**Reference: Kanata North – CU Developments Inc.
Draft Plan of Subdivision and Zoning By-law Amendment Applications
Planning Rationale Addendum
City File Nos.: D02-02-18-0076 & D07-16-18-0023
Our File No.: 116132**

This addendum responds to the CEPEO's and the City's request for revisions to the Planning Rationale to address their respective comments.

Appendix 1: Natural Feature Open Space Area Comparison

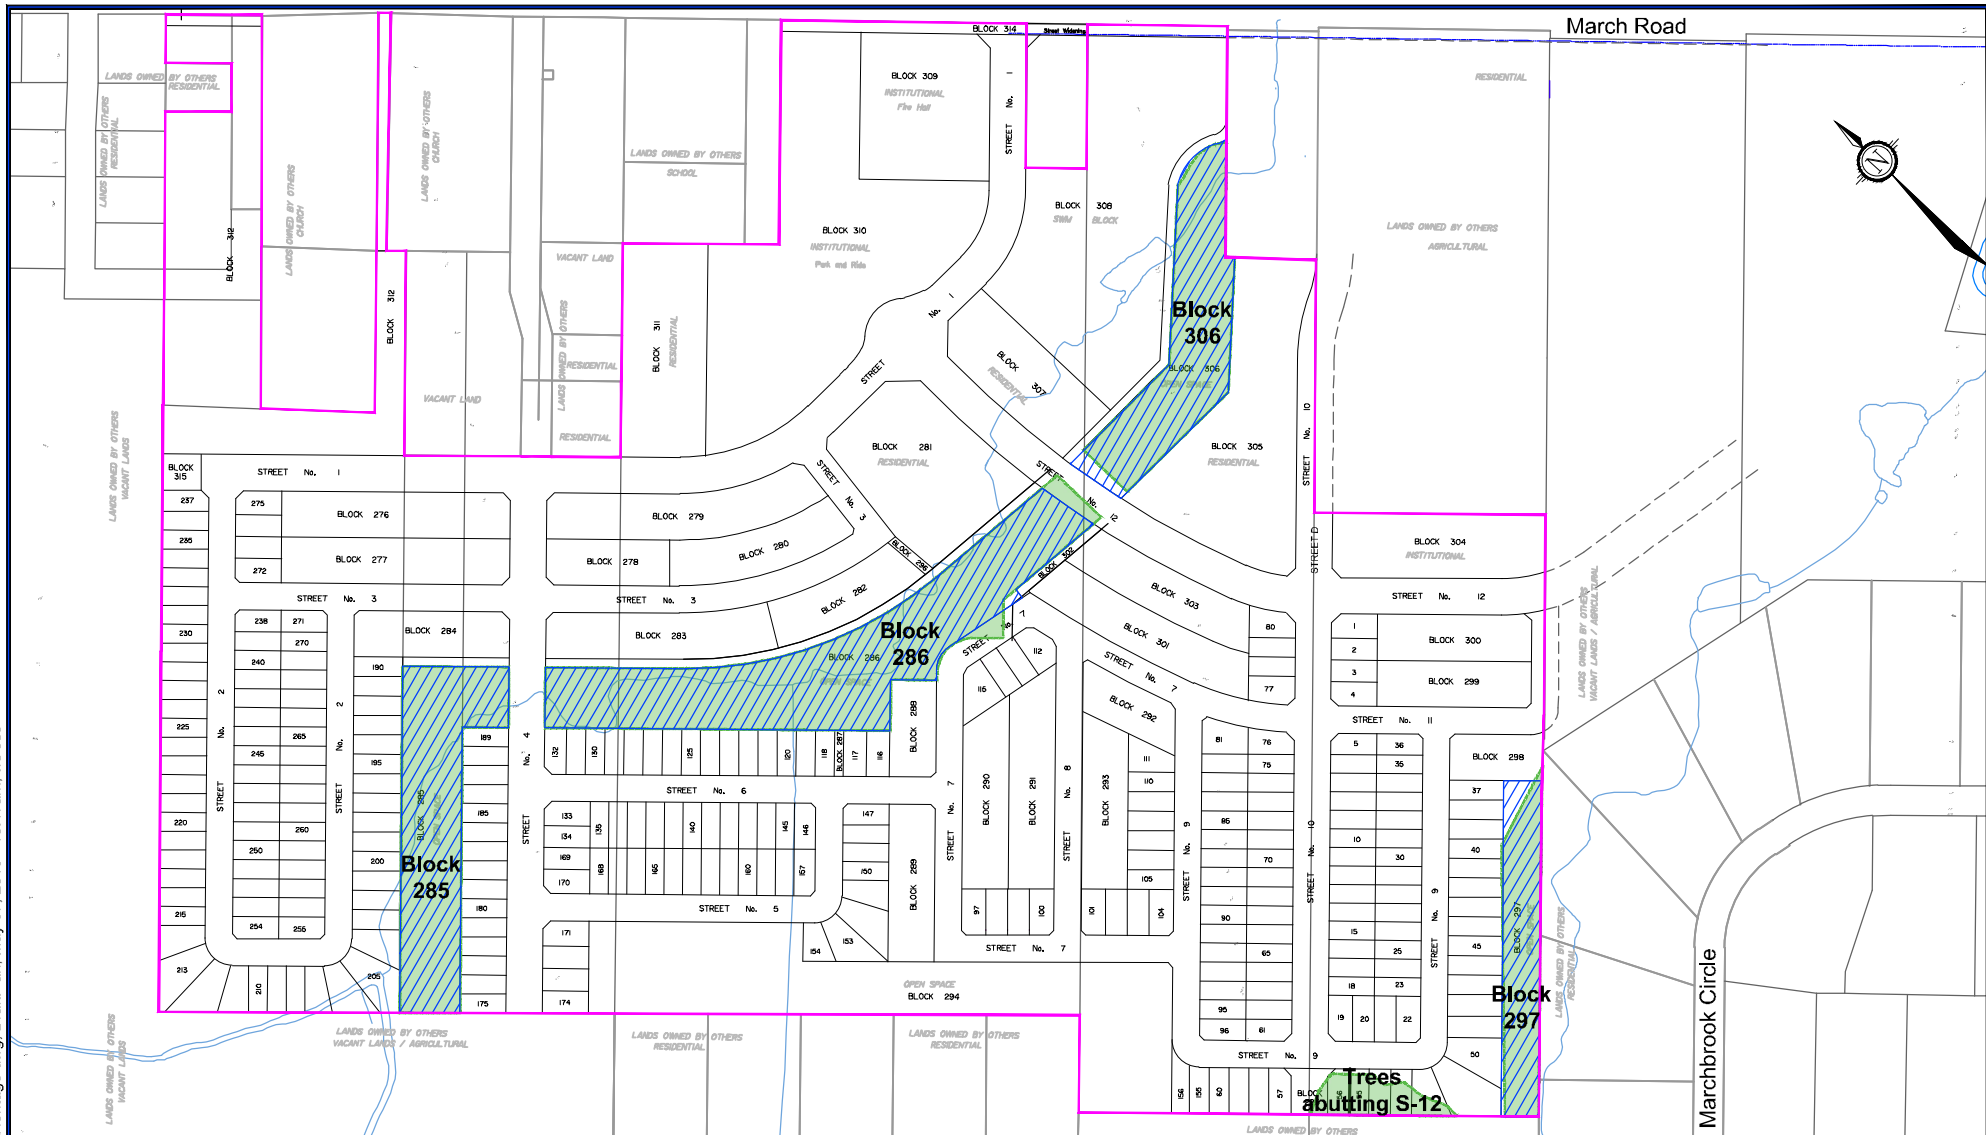
Please include a chart in the planning rationale comparing how much land has been added to the Shirley's Brook corridor (block 285 and 286) and Block 297 vs what was proposed for the retained natural feature abutting Woodlot S-12 in the CDP demonstration plan. Subject to a minimum net-zero change in the total amount of space preserved, an OPA will not be required to remove the Urban Natural Features designation from Schedule B.

The following table provides a comparison of the Open Space area attributed to natural features in CU Development Inc.'s (CUD) lands in the Kanata North Community Design Plan (CDP) Demonstration Plan (2016) and CUD's Draft Plan of subdivision (see Appendix 1 for an area comparison figure):

CDP Demonstration Plan	CUD Draft Plan
Tributary #2	Block 285	1.03ha	1.03ha
	Block 286	1.79ha	1.73ha
	Block 306	0.88ha	0.93ha
Tributary #3 (Block 297)		0.50ha	0.55ha
Subtotal		4.20ha	4.24ha
Open Space/Natural Feature abutting Woodlot S-12		0.18ha	0.00ha
Total Area		4.38ha	4.24ha

As noted in the area comparison table, there is a 0.14ha area difference between the open space provided for natural features in the CDP Demonstration Plan and the CUD Draft Plan. However, at the time the CDP Demonstration Plan was created, the stand of trees in the southwest corner of the subdivision lands was still linked to Woodlot S-12, thereby justifying its protection as a natural feature. As stated in Section 4.2 of the Planning Rationale, the forested area that linked the stand of trees in the subdivision lands to Woodlot S-12 was completely cleared by the abutting landowner after the Demonstration Plan was approved (see Figures 14 and 15 in the Planning Rationale). The Environmental Impact Statement/Tree Conservation Report (dated June 2018) therefore concluded that there is no longer ecological value in preserving the stand of trees in the subdivision lands.

Since the southwest tree stand is no longer linked to Wood-lot S-12, it should no longer be considered natural feature that must be protected. Tributaries 2 and 3 are still natural features and the CUD Draft Plan provides 0.4ha more of open space along them than what was shown in the CDP Demonstration Plan, as indicated by the subtotal in the table above.
